The Hon Robert Stokes MP

2 April 2021

Snowy 2.0 Transmission Connection Project Environmental Impact Statement

Figure 6 – Comparison of Existing KNP Transmission Lines, Proposed Lines and Trench

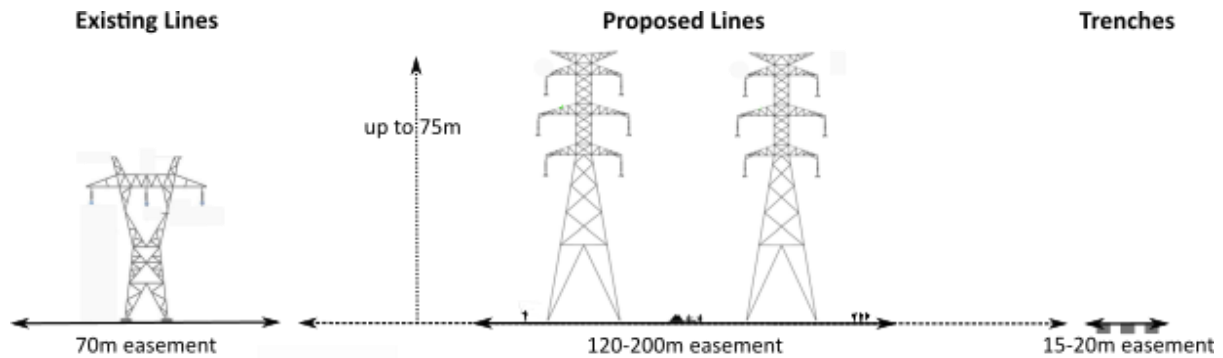
Figure 6, copied from Attachment B, depicts the most environmentally impactful underground technique, being trenching, with a cleared easement of around 15-20m compared to existing and proposed lines in KNP. Other underground techniques (tunnels and directional drilling) are less impactful, involving no above ground structures and no, or minimal, cleared easement.

Clearly, the proposed overhead lines are substantially more intrusive than the existing transmission lines and all underground techniques.

Figure 7 – Visibility of transmission lines across 300 km² (EIS App H)

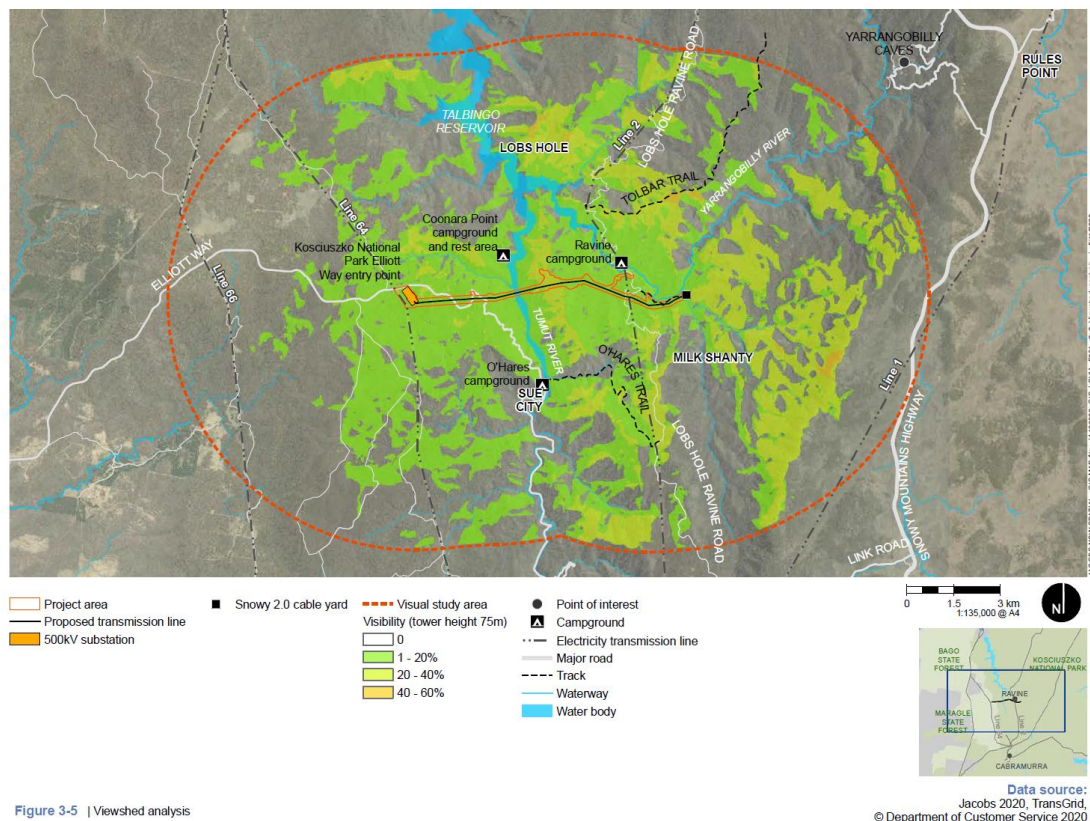
Figure 7, taken from Appendix H of the EIS (page 20), shows an area of approximately 300 square kilometres over which the proposed lines will be visible. The towers and lines will completely dominate the skyline in the Yarrangobilly and Tumut River valleys.

Figure 9 – Cable tunnel from Lobs Hole to Maragle

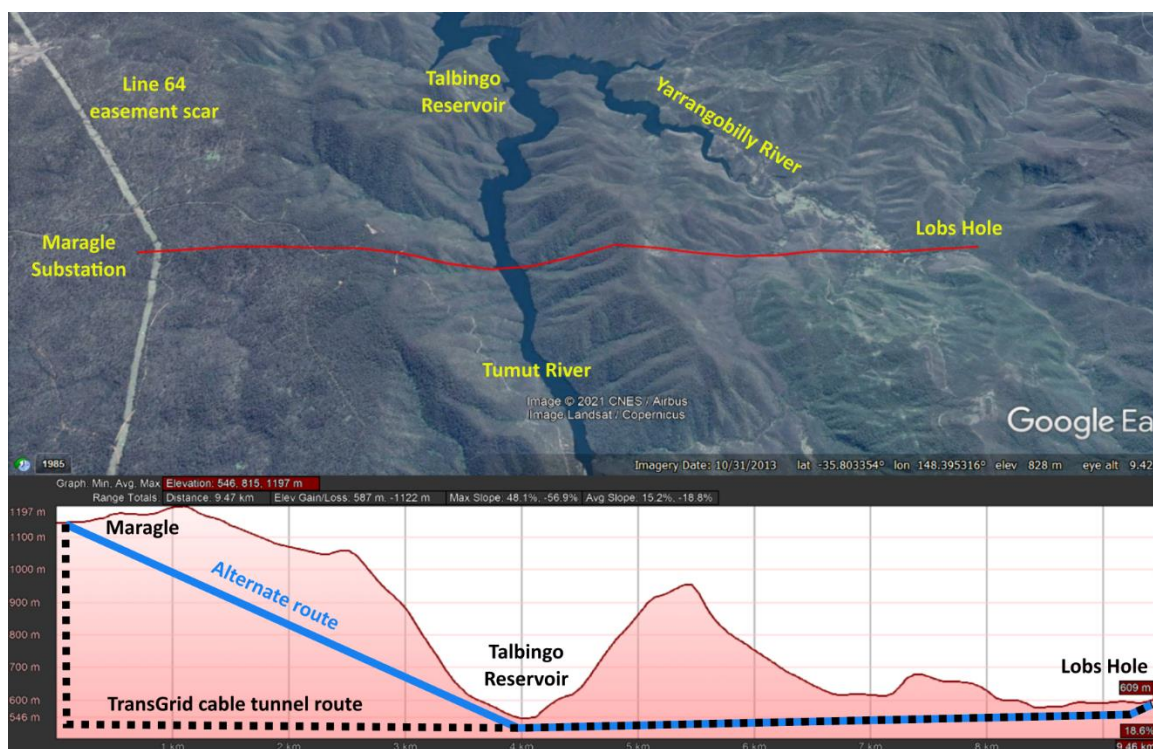
Response: TransGrid has only considered a horizontal tunnel from Lobs Hole and then a vertical shaft up to Maragle (see indicative dashed black line Figure 9). NPA would agree that this approach presents potentially insurmountable engineering challenges.

But why present the most difficult and impractical option, and use that as the reason to rule out tunnelling altogether?

The obvious approach would be to use a tunnel boring machine (TBM) that can bore at an incline. It would start at Maragle, bore a tunnel down to Talbingo Reservoir and then transition to a roughly horizontal tunnel to Lobs Hole (see indicative blue line in Figure 9).

Figure 11 – LTSS is located in a cleared landscape with low bushfire risk

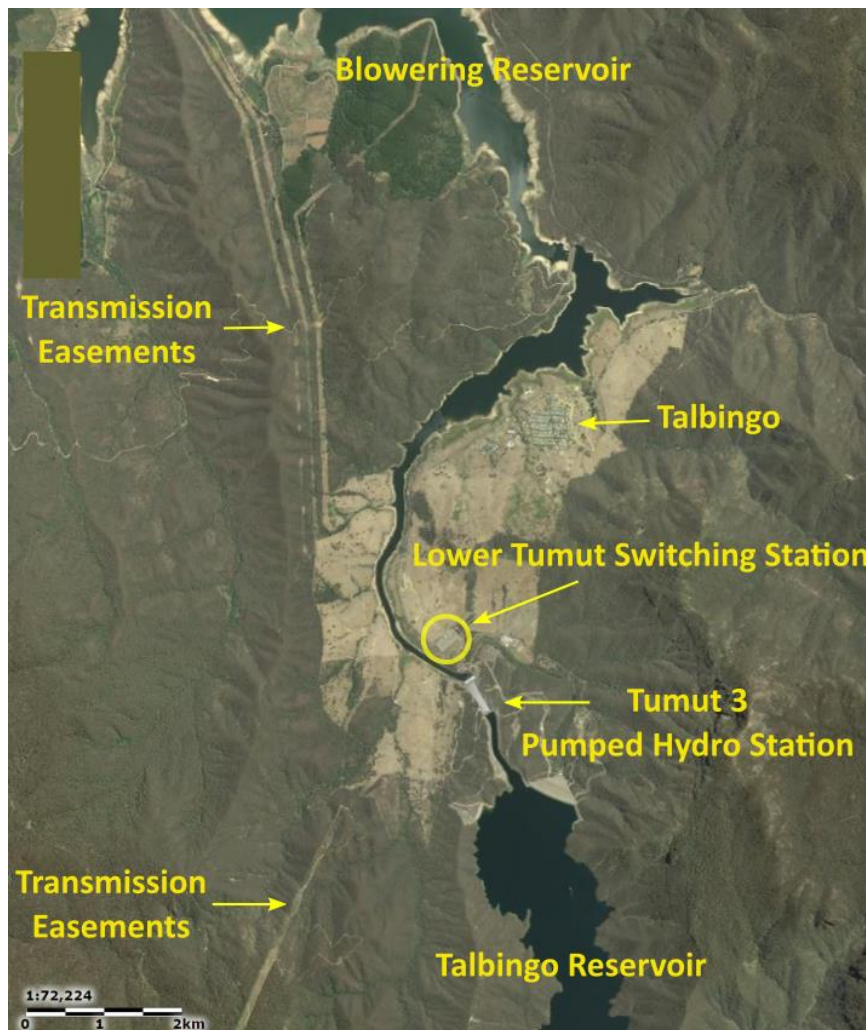
Figure 11 shows that the area around LTSS is cleared of bush vegetation for a kilometre or two, except a small arc to the south east. There has been no history of bushfires threatening the Switchyard since its construction 50 years ago.

Figure 12 – Proposed Maragle Substation, Bago State Forest

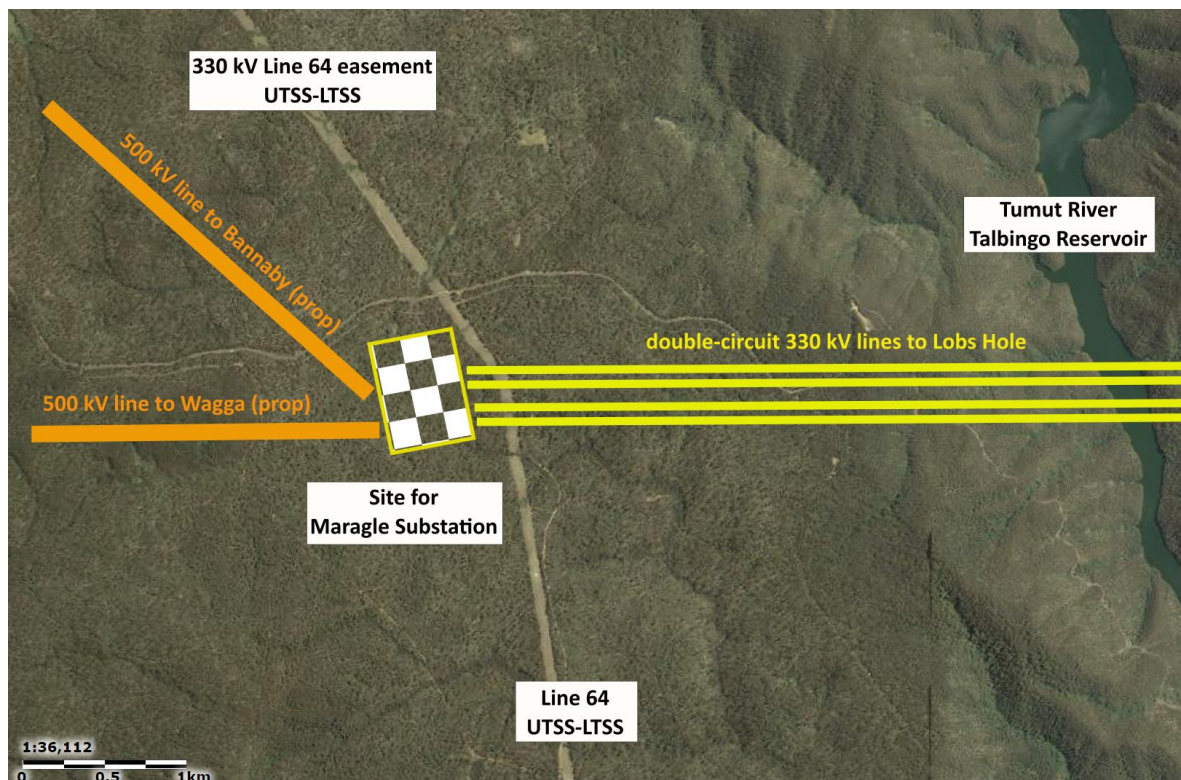
As shown in Figure 12, the proposed Maragle Substation is in the middle of Bago State Forest, where the bushfire risk is many times greater than at LTSS. The EIS notes the consequent need to separate the two Humelink connections:

Of course, underground cables introduce no such risks.

Figure 2 – Layout of Snowy 2.0 Transmission Connection Project

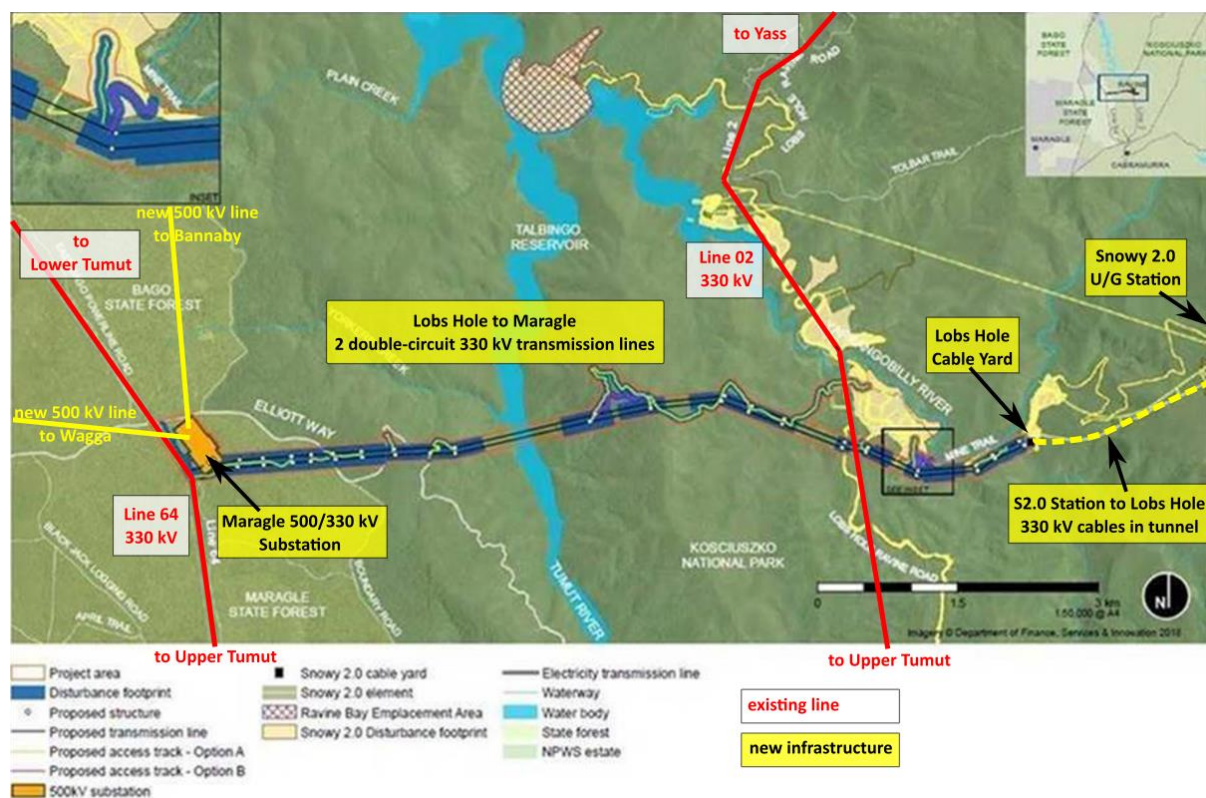
- two double-circuit 330 kV overhead transmission lines (on two sets of side-by-side towers³⁰)
- traversing about eight km of KNP and one km of BSF, connecting the Lobs Hole Cable Yard (near the entrance to the Snowy 2.0 underground Station) with a new Substation (Maragle) in BSF (see the two parallel black lines and dark blue 'disturbance footprint' in Figure 2)
- twenty-one sets of steel lattice towers, each up to 75m high
- an easement varying from 120m to 200m in width
- a series of new access tracks (the green lines in Figure 2)

Figure 4 – Comparison of Existing KNP Transmission Lines, Proposed Lines and Trench

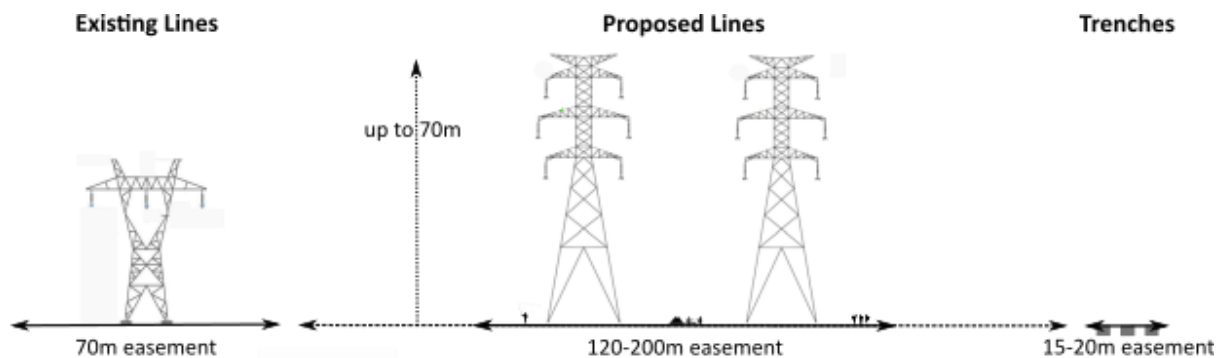
Whilst the existing transmission lines in KNP, built before the National Park was established in 1967, are an eyesore and environmentally damaging, they are far less imposing and intrusive than the proposed lines (see Figure 4 – the campers and bushwalkers at the base of the towers indicate the scale). Compared to the existing lines, the proposed transmission lines will have:

- two sets of side-by-side towers, compared to one set of towers for the existing lines
- two circuits per tower (of three phases), compared to one circuit
- 28 individual wires strung between towers, compared to 8
- much higher towers (conductors strung vertically), compared to shorter towers (conductors strung horizontally)
- easements of 120 – 200m wide, compared to 70m

For comparison, Figure 4 includes a depiction of the most environmentally impactful underground technique, being trenching, with a cleared easement of around 15-20m. Other underground techniques (tunnels and directional drilling) are less impactful, involving no above ground structures and no, or minimal, cleared easement (Section 4.2).
